South of Hawkshead Road, Little Heath: HS24 BrP7

Addendum to Statement of Common Ground between Welwyn Hatfield Borough Council and Royal Veterinary College.

Section A-A
Scale 1:200

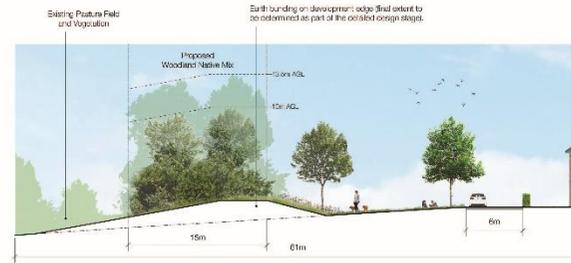
Cross sections have been prepared to indicate the screening potential of this proposal. These show that views from the footpath to the west of the site will be of the tree screen and the dwellings will not be visible. This includes the existing

dwellings which are currently visible on the skyline in these views. The cross sections are in Annex A to this addendum.
